Report: Deficiency Report
Function: Test, Adjust, & Balance
Date: 11/11/2024
Completed By: National TAB

11-11-24 WAWA #5438 ALACHUA, FL

Project: 11-11-24 WAWA #5438 ALACHUA, FL

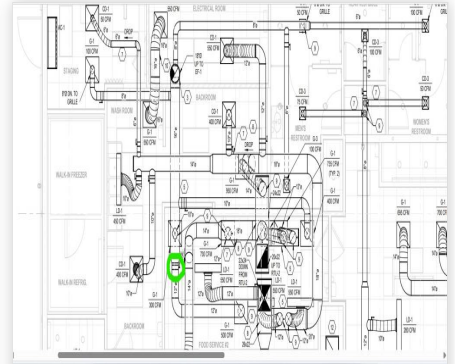
Issue Name : EF-1 Vent 1 Damper
Description : Damper missing from EF-1 Vent 1. This vent is 113.4% high and is preventing other vents from being in design. Recommend having mechanical install damper to allow all vents to be in design.
Created By : National TAB **Assigned To :** National TAB - Kristopher Passley
Status : Open
Priority : Urgent **Asset Tag :**
Originated Date : 11/13/2024 - Kristopher Passley - National TAB

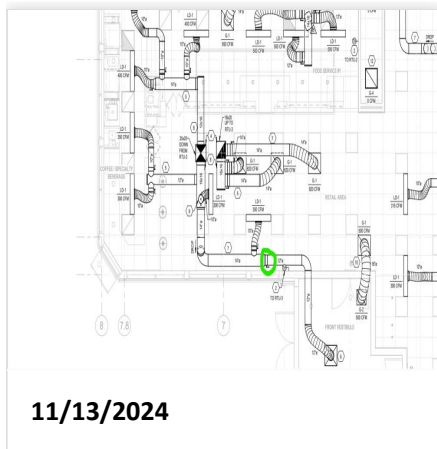
Issue Name : EF-2 Power
Description : EF-2 doesn't not have power. Recommend electrician wire power to the fan.
Created By : National TAB **Assigned To :** National TAB - Kristopher Passley
Status : Closed
Priority : Urgent **Asset Tag :**
Originated Date : 11/11/2024 - Kristopher Passley - National TAB

- **11/13/2024 National TAB - Kristopher Passley**
 - Issue is resolved. EF-2 now has power.

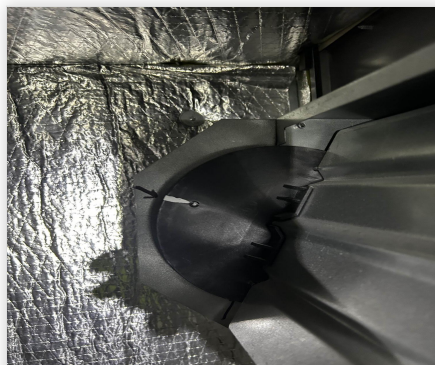
Issue Name : RTU-3 Diffuser 1 Damoer
Description : Damper missing from RTU-3 Diffuser 1. Diffuser is at 120% and needs airflow to be reduced to have diffuser with design. Recommend mechanical install damper as per plan.
Created By : National TAB **Assigned To :** National TAB - Kristopher Passley
Status : Open
Priority : Urgent **Asset Tag :**
Originated Date : 11/13/2024 - Kristopher Passley - National TAB
